COIL NAILER

Model AN901(MJ)

SERVICE CHANGES

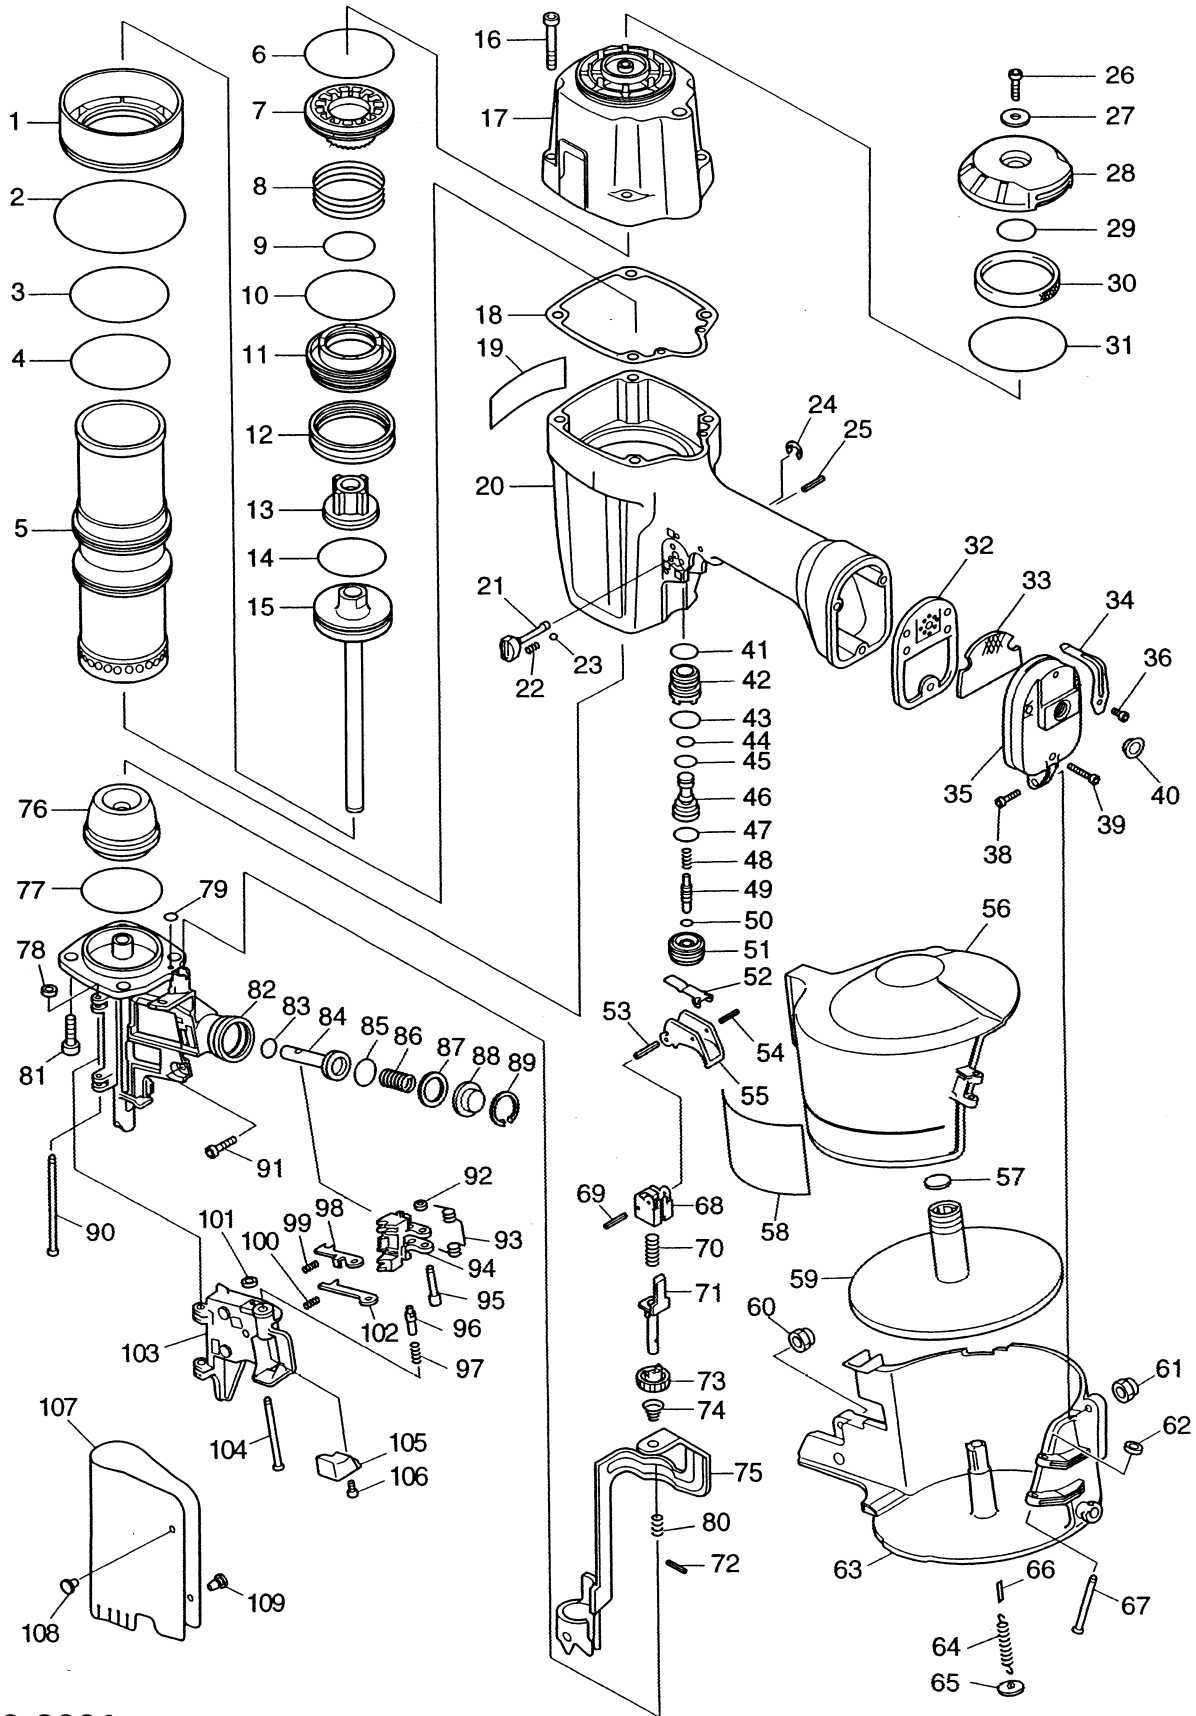
1. The Material of the Pilot Valve and Trigger Valve Case WAS changed from Resin to Aluminum.

Item No.	Description	Type 1	Type 2	Type 3
42	Trigger Valve Guide	416806-0	417695-6	
46	Pilot Valve	416804-4	417694-8 Resin: White (No Longer Available)	317520-0 Aluminium: Silver
51	Trigger Valve Case	416805-2 Resin: White		317521-8 Aluminium: Silver

Above parts are completely interchangeable as a set.
Trigger Valve Guide Type 1 and Type 2 are interchangeable as themselves.
Pilot Valve Type 1 and Type 2 are interchangeable as themselves.
